## SUNDRY NOTICES AND REPORTS ON WELLS

PLEASE SEE THE ATTACHED P&A PROCEDURE. APACHE CORPORATION WOULD LIKE TO PLUG AND ABANDON THE ABOVE MENTIONED WELL BY THE PROPOSED PROCEDURE.

Southeast Lusk 27 Federal

30-025-38678

# PROPOSED PROCEDURE

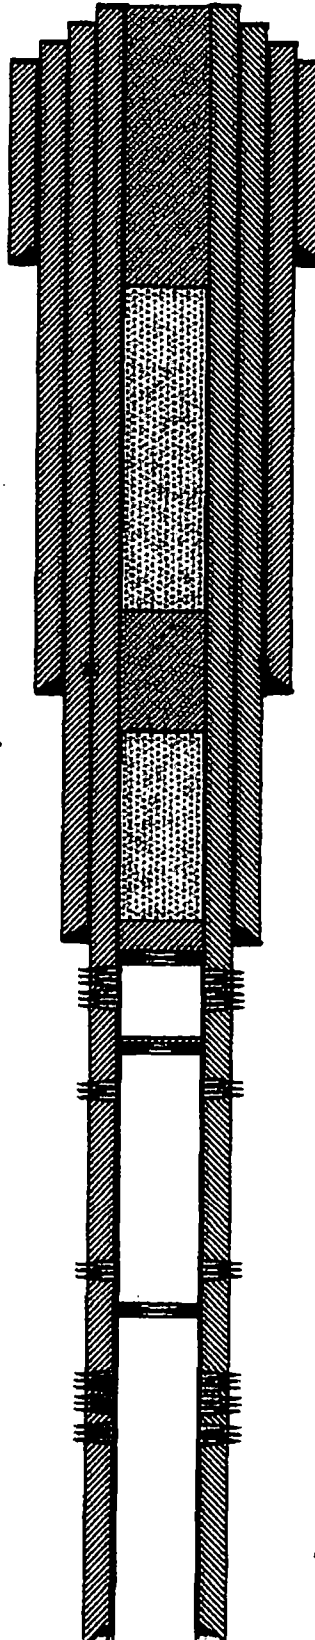
*Secretary's Potash*SEE ATTACHED FOR  
CONDITIONS OF APPROVAL*Below ground level dry hole marker required*

*Add. Plug (T/salt). Spot  
25 sx from 1380-1280  
WOC Tag*
